**Vogtle Electric Generating Plant – Units 1 and 2
Request for Additional Information Response Regarding
Proposed Inservice Inspection Alternative VEGP-ISI-ALT-07**

SNC Response to NRC RAI Regarding VEGP-ISI-ALT-07

FIGURE RAI #1-1a TYPICAL CONFIGURATION OF VOGTLE UNIT 1 CRDM NOZZLES 1 THROUGH 78 AND VOGTLE UNIT 2 CRDM NOZZLES 74 THROUGH 78 AS DEPICTED ON FIGURE 2 OF CODE CASE N-729-1
NOT TO SCALE

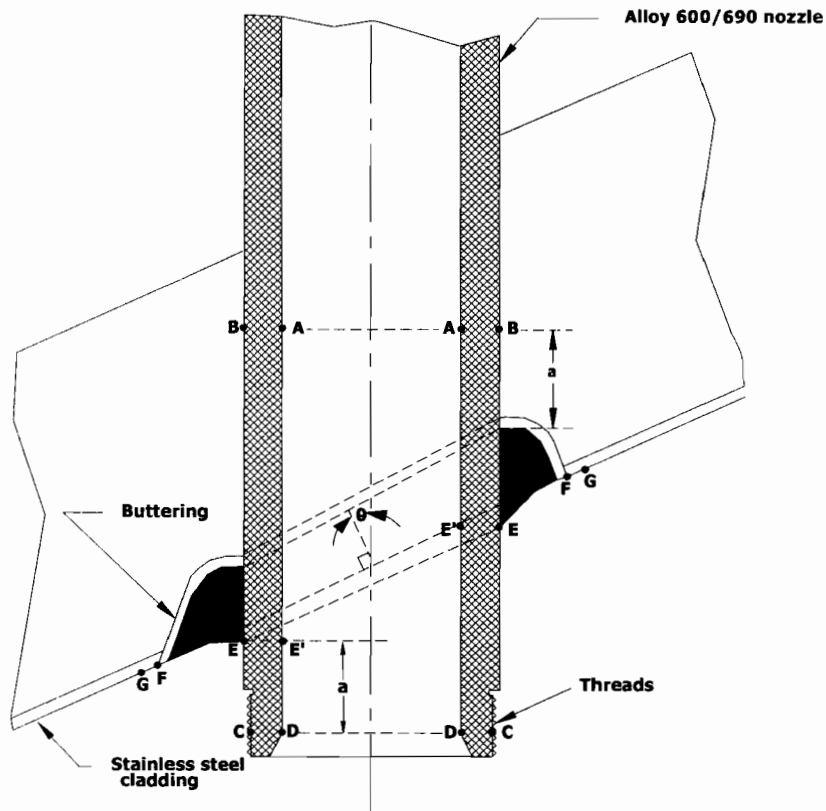
The licensee referenced Figure 2 in ASME Code Case N-729-1 for the examination of the reactor vessel head nozzle penetrations. It appears that the penetration at Vogtle is slightly different from Figure 2 of N-729-1 in that the lower region of the Vogtle penetration nozzle is threaded. Figure 2 of Code Case N-729-1 uses alphabetic letters to identify specific areas/regions of interest for the J-groove weld and nozzle. The relief request discussed the following areas/regions of interest: the bottom of the fillet, the toe of the J-groove weld, chamfered regions, regions having a radius, the distance between the lowest point at the toe of the J-groove weld and the bottom of the scanned region, the proposed alternative examination zone, incidence angle, thread sections, thread relief, and shadow zone in the threaded region. It is not clear to the staff how these terms relate to the "lettered" dimensions in Figure 2 of ASME Code Case N-729-1. (a) Please provide a drawing(s) of a typical control rod drive mechanism penetration nozzle showing the threaded region with a tapered inside surface at the bottom of the CRDM nozzle. (b) In the drawing, please identify the items that correspond to the letters used in Code Case N-729-1 and to the areas/regions mentioned in the relief request.

Southern Nuclear (SNC) is providing four sketches to provide additional details for the actual configuration of the nozzles. Figure RAI # 1-1a shows the configuration of the Unit-1 CRDM nozzles 1 through 78 and the Unit-2 CRDM nozzles 74 through 78. Also enclosed is Figure RAI # 1-1b which provides the details of the threaded/chamfered nozzle end (Type X). The toe of the weld is located above the reduced cross section. Figure RAI # 1-2 shows the configuration of the Unit-2 CRDM nozzles 1 through 73. In addition, Figure RAI # 1-3 shows a top view of the Units 1 and 2 reactor pressure vessel (RPV) head CRDM configuration in order to show the relative location of the CRDMs. Figures RAI # 1-1a and 1-2 were generated from Figure 2 from ASME Code Case N-729-1 to help identify the required examination volume and the physical limitations. The coverage lengths listed in Tables 1 and 2 of the proposed ISI alternative corresponds to the "a" dimension (below the J-groove weld) identified in Figure 2 of ASME Code Case N-729-1.

- a) The limitations observed for the Unit-1 volumetric examinations are based on the additional chamfered/threaded regions. This is clearly seen in Figures RAI # 1-1a and -1b, which portray the Unit-1 CRDM penetrations. The configuration on Unit-2 does not have the same limitation (except for nozzles 74 through 78).

- a) Table RAI # 5-1 shows the twenty-two Vogtle CRDM penetration nozzles included in this ISI alternative. The two sections of the table show the initial thirteen nozzles and the nine additional nozzles. The alternative examination zone extends from the toe of the weld down the nozzle for the dimension identified in Table RAI # 5-1, as noted in the column listing "a". This is the "a" dimension below the weld shown in Figures RAI # 1-1a and RAI # 1-2 added to address RAI question # 1.
